FED. ROAD DIST. NO.	STATE	FED. AID PROJ. NO.	FISCAL YEAR	SHEET NO.	TOTAL SHEETS
HAWAII	HAW.	I-H3-I(61)	1990	281	424

HALAWA APPROACH

HAIKU APPROACH

DATE	REVISION
8/6/92	REVISED DOMESTIC WATER GPM AND SANITARY GPM & TANK SIZE PER DCN61-031
4/26/90	DELETED NOTE: 25 GPM FROM CONTROL BUILDING
STATE OF HAWAII DEPARTMENT OF TRANSPORTATION HIGHWAYS DIVISION WATER BALANCE DIAGRAM STANDARDS INTERSTATE ROUTE H-3 F.A.I. PROJ. NO. I-H3-I(61)	
SCALE: NONE	DATE: JAN 1990
SHEET NO. M2	OF 8 SHEETS

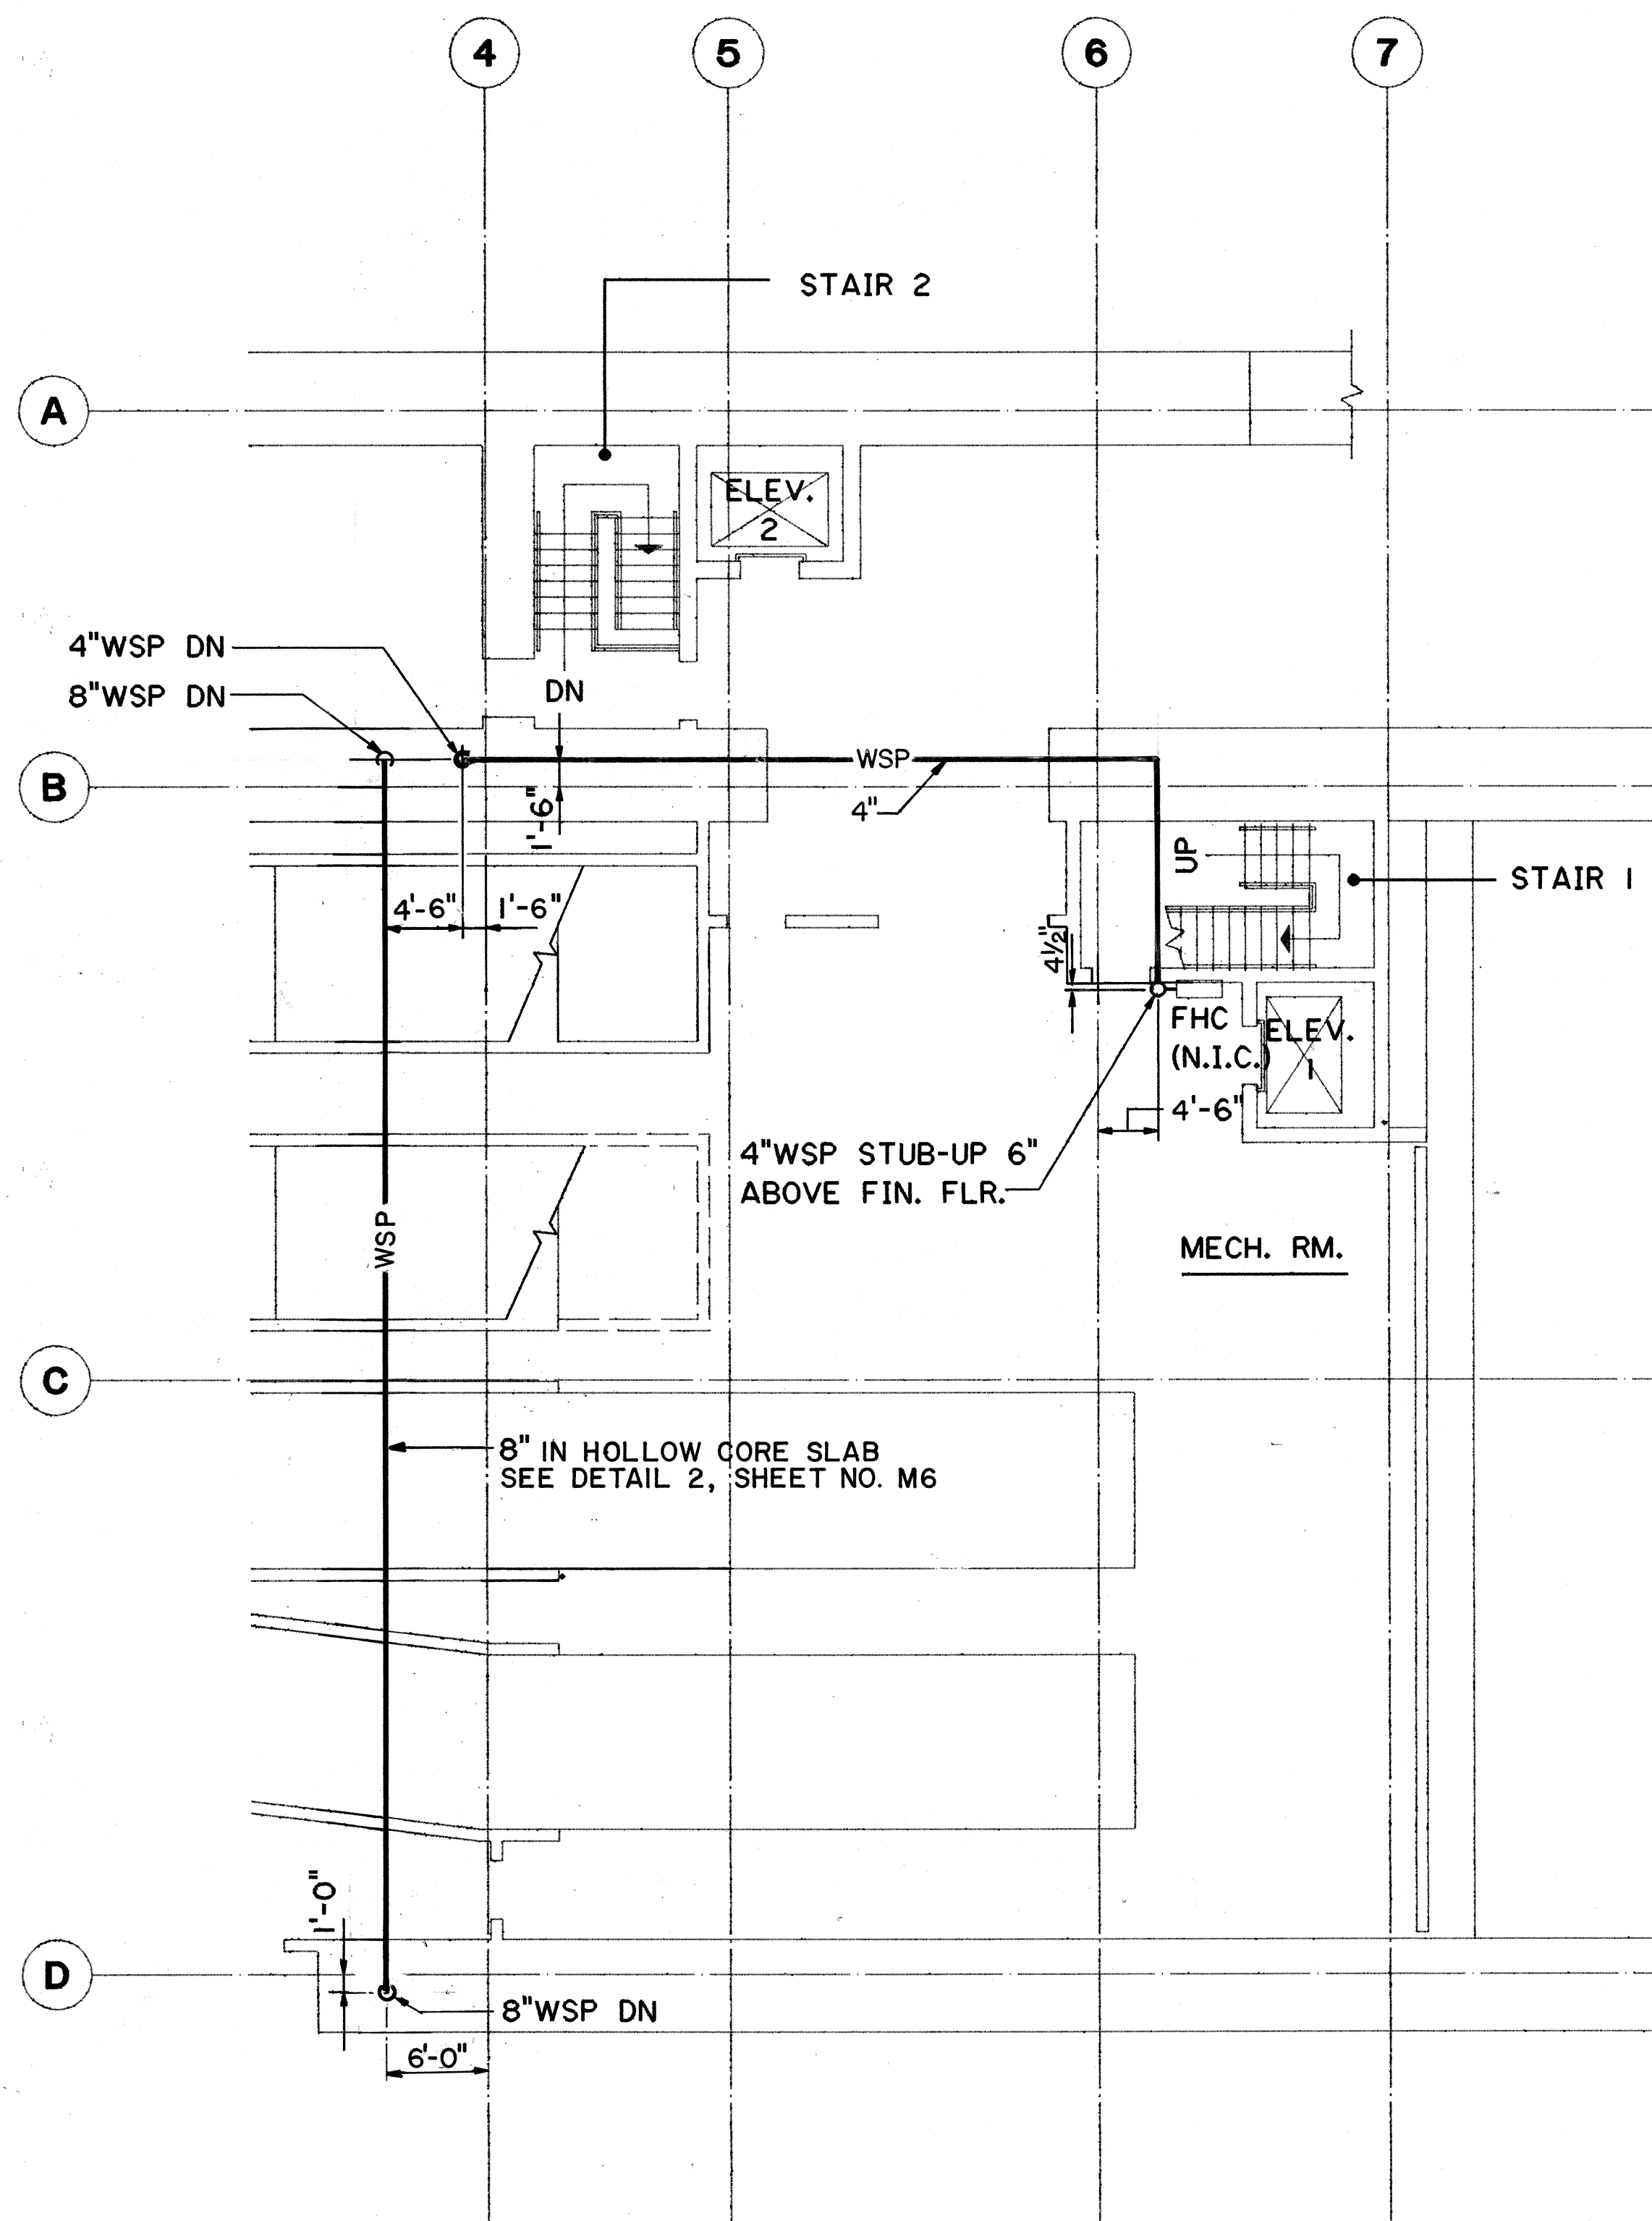
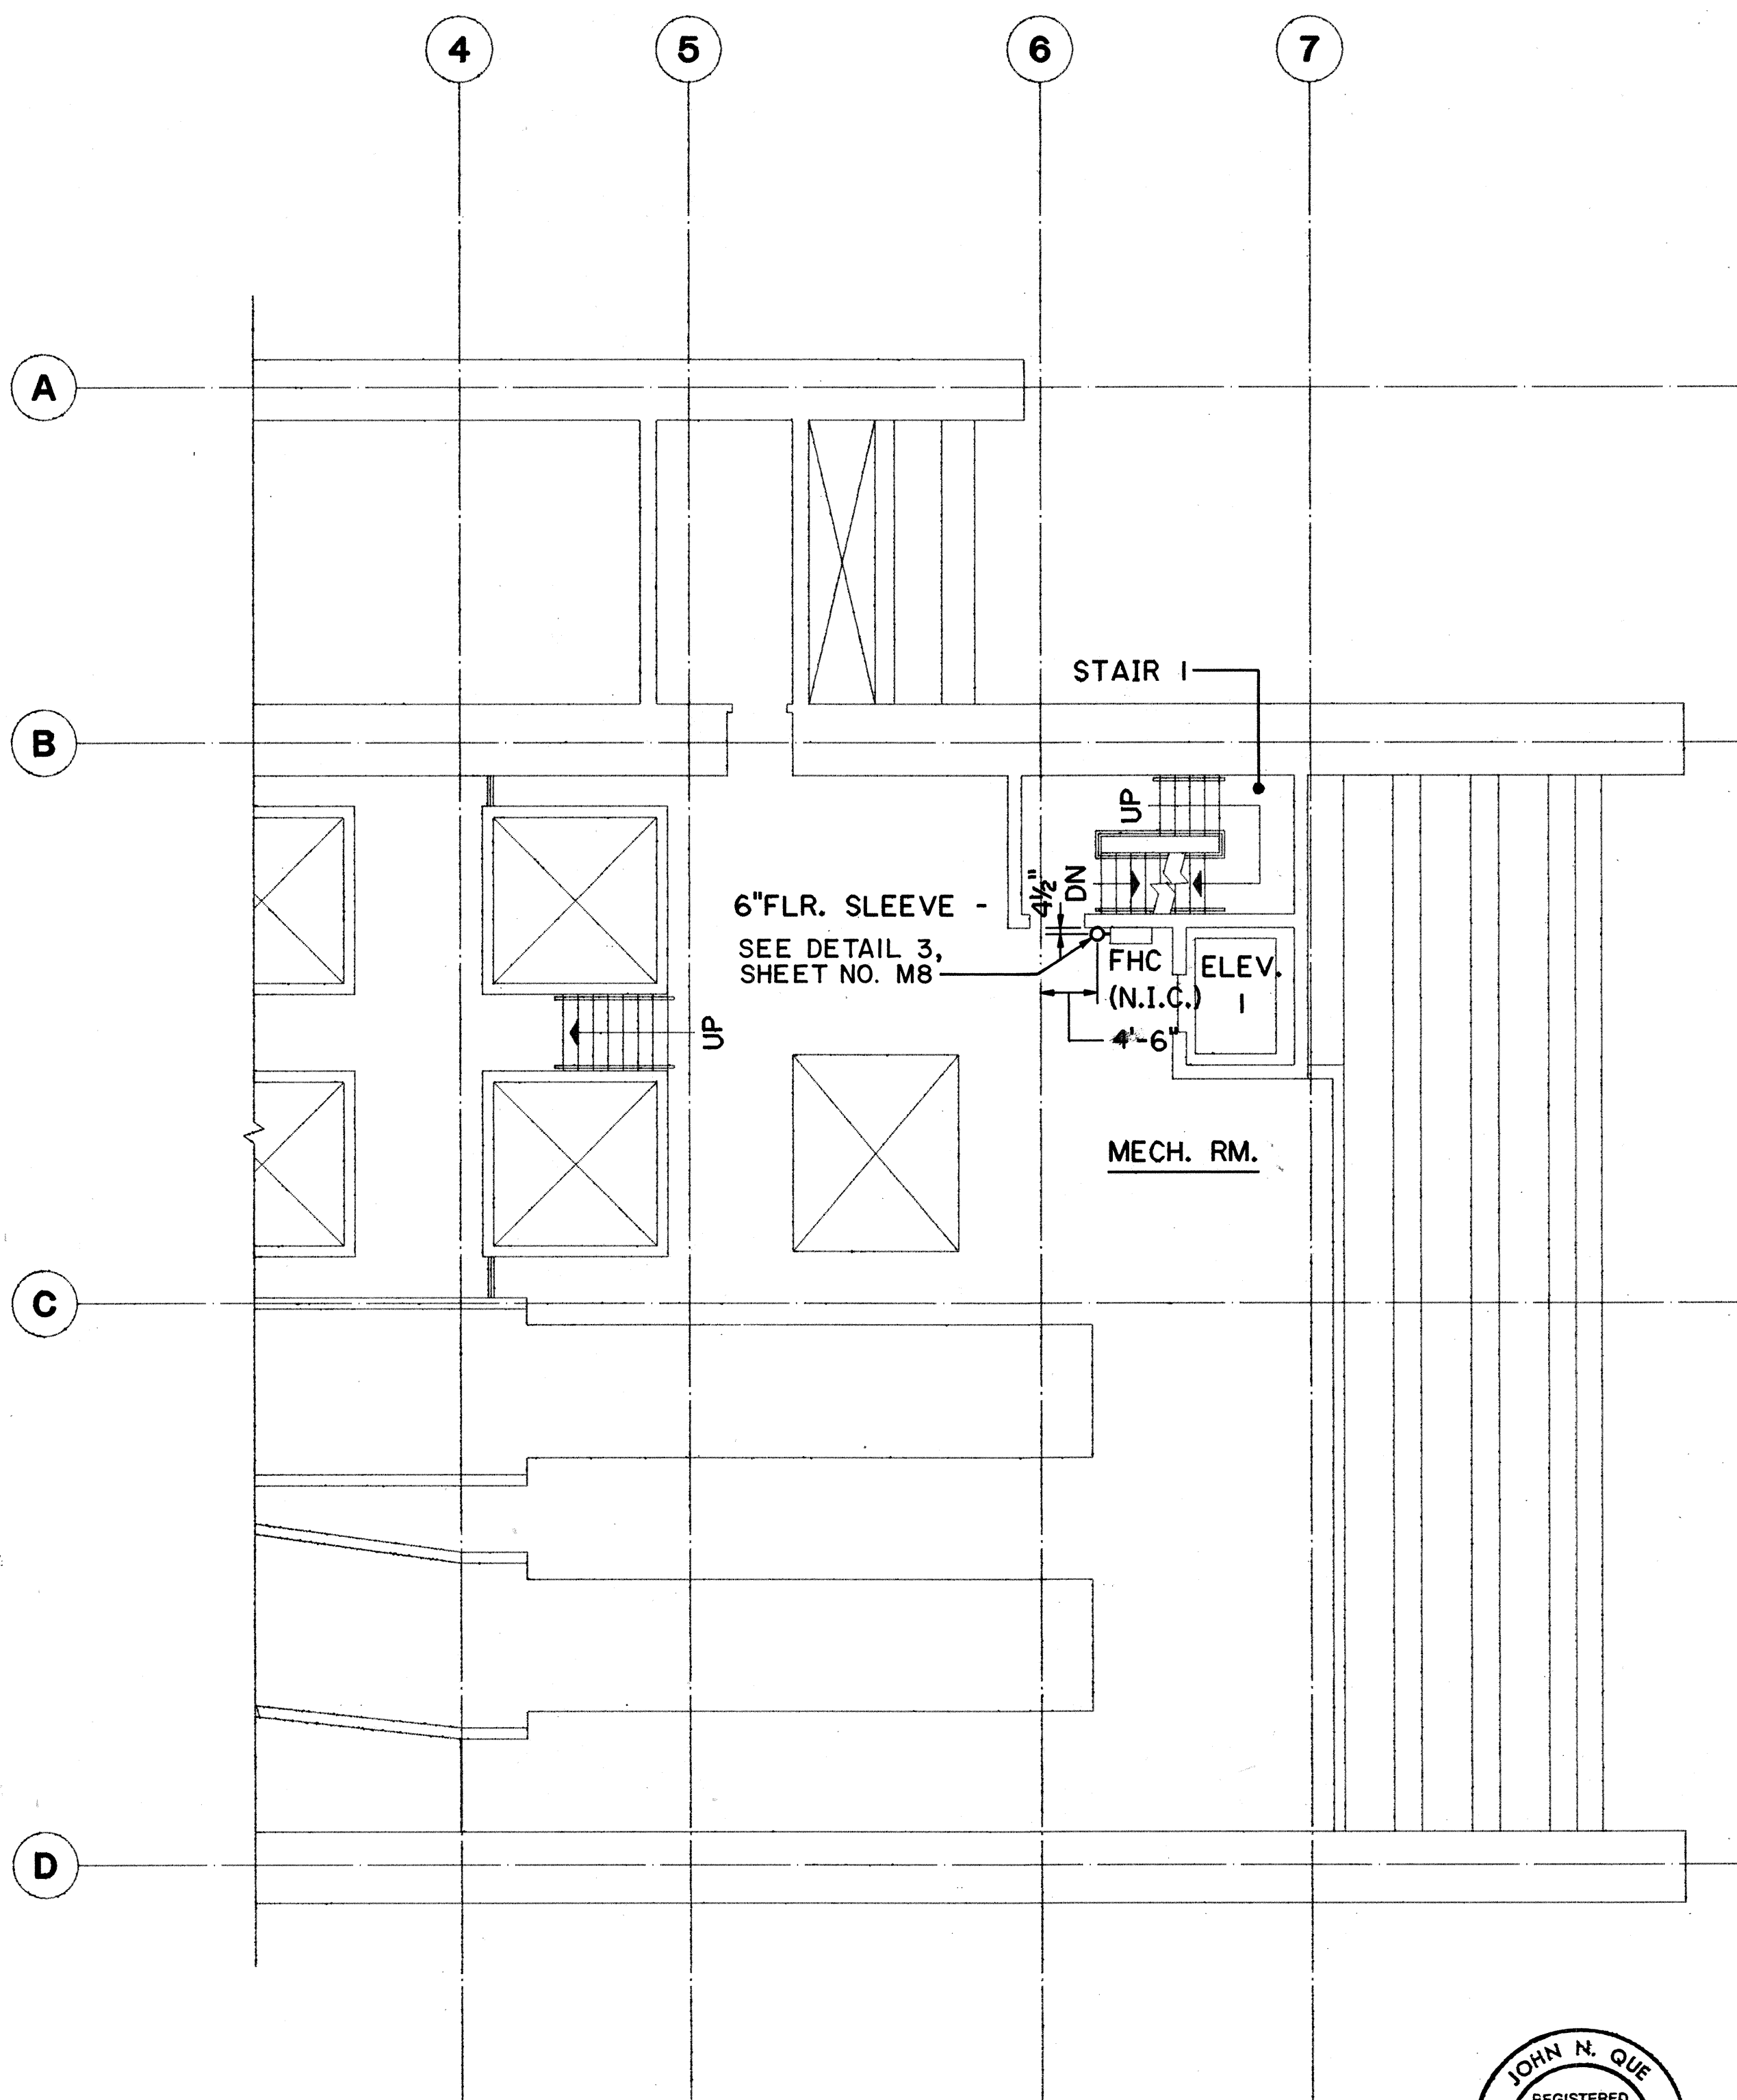
DATE	REVISION
4/6/91	REVISED 8" WSP DIMENSIONS PER DCN No. 61-009
4/26/90	REVISED 8" WSP DIMENSIONS 4'-6" TO 6'-6" & 7'-6" TO 8'-0" FROM COL. LINE 4
STATE OF HAWAII DEPARTMENT OF TRANSPORTATION HIGHWAYS DIVISION FIRE PROTECTION-LEVEL 2 & LEVEL 3 PARTIAL PLANS HAIKU PORTAL BUILDING-OB INTERSTATE ROUTE H-3 F.A.I. PROJ. NO. I-H3-1(61) SCALE: 1/8"=1'-0" DATE: JAN 1990 SHEET NO. MQ10 OF 11 SHEETS
